Agenda Report

May 16, 2016

SUBJECT: PREDEVELOPMENT PLAN REVIEW FOR 3202 EAST FOOTHILL BOULEVARD MIXED USE PROJECT (SPACE BANK)

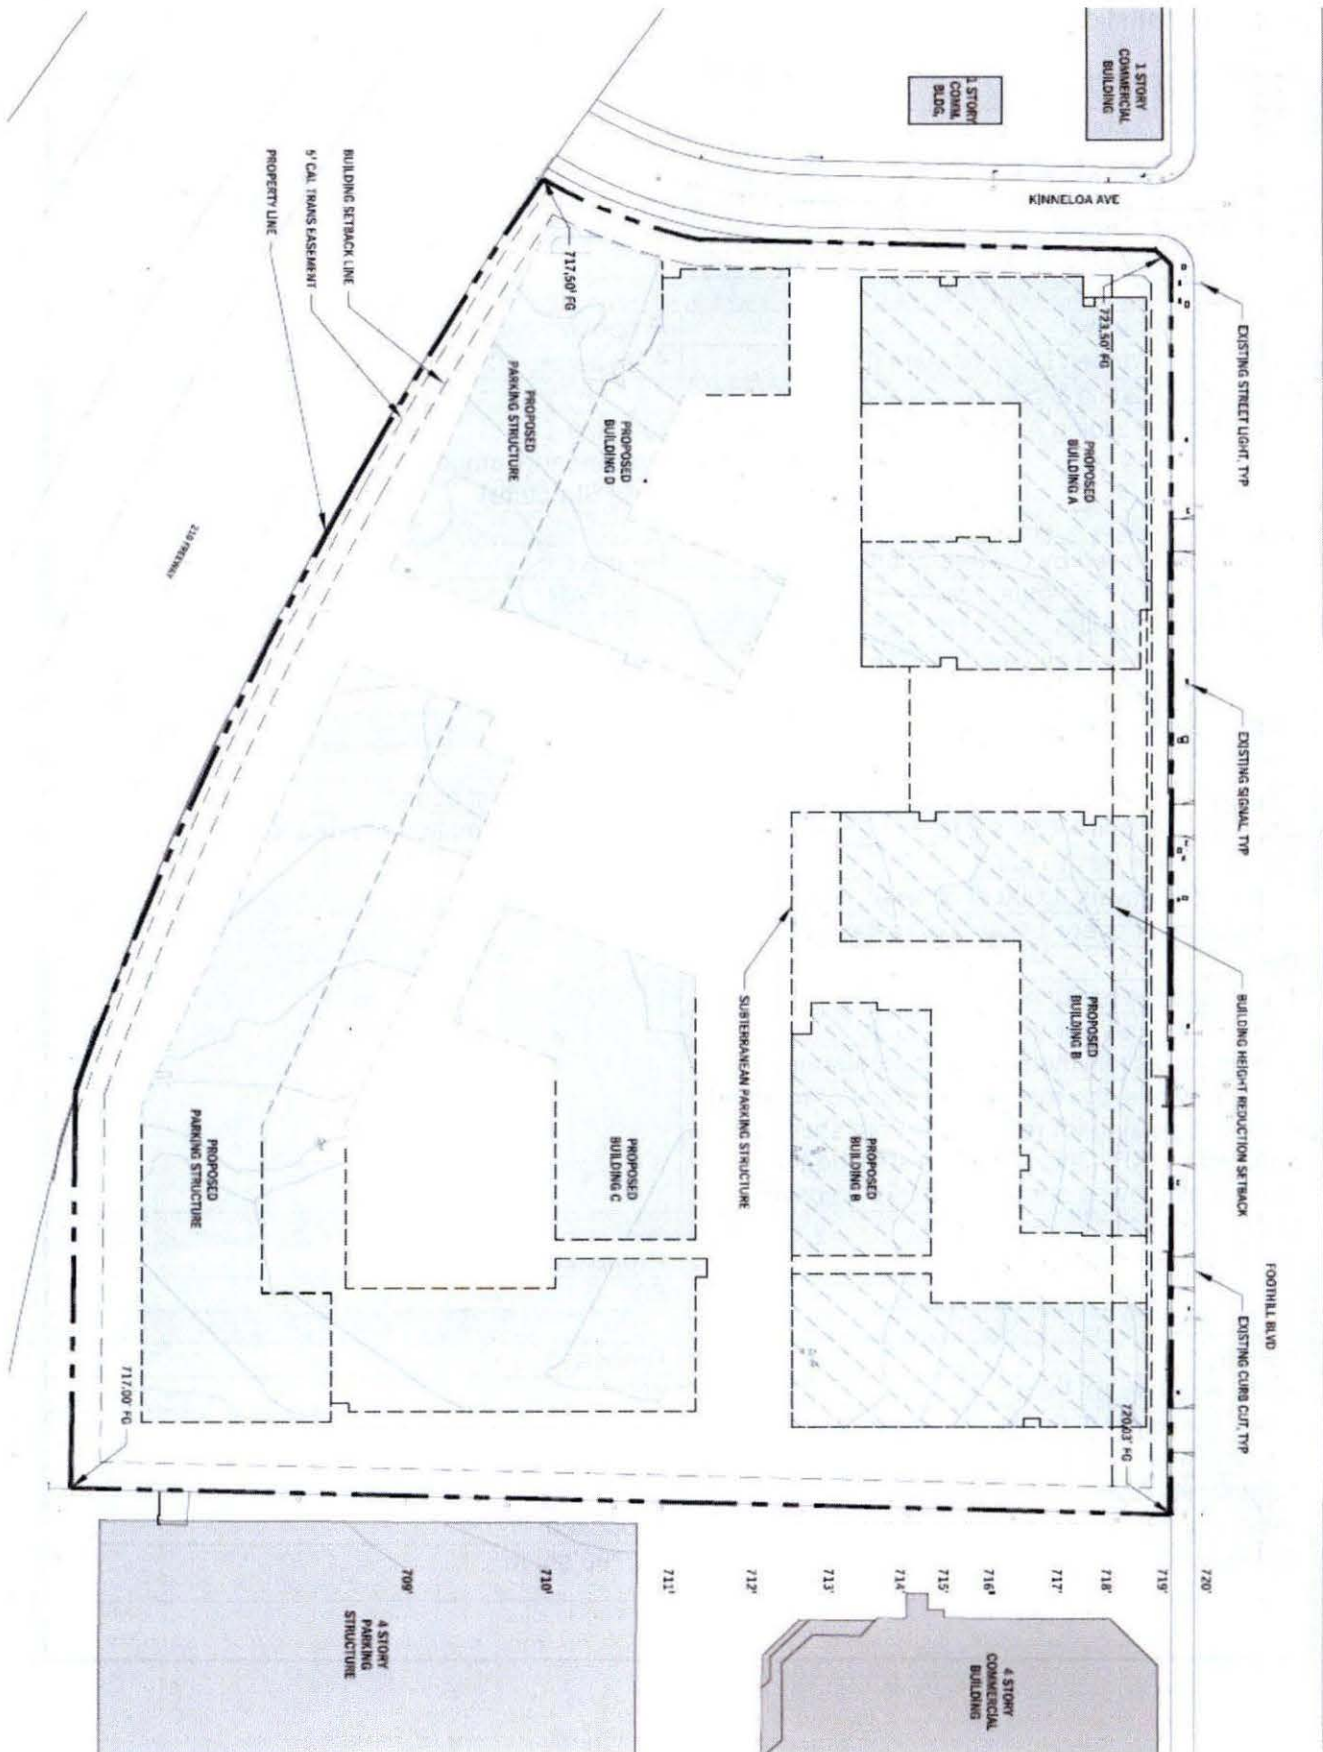
1. Closely study the connection between interior open spaces, building frontages, pedestrian pathways and the public realm to ensure that the project appropriately engages with the street and responds to the collective form of surrounding neighborhoods. Consider orienting buildings to provide more common access to open space and build a greater sense of connection between residents and the public realm.
2. Study the interaction between pedestrian and vehicular access within the site and the possibility of relocating the proposed primary vehicular access to the site to North Kinneloa Avenue. Consider minimizing the width and visual prominence of the continuation of Santa Paula Avenue through the middle of the site to enhance and encourage additional pedestrian flow at that location and maintain a greater sense of

6. Study the balance of sunlight and shade in the long, narrow courtyard of Building B. Consider increasing the distance between the two components of Building B to create a more engaging, pedestrian-oriented space.

14. Explore a more fine-grained design and review the possibility of breaking down the building massing through the use of additional smaller buildings rather than fewer larger buildings. Increasing the number of buildings may create additional opportunities for more pedestrian pathways and site permeability, which would further contribute to a village like feel at the site.
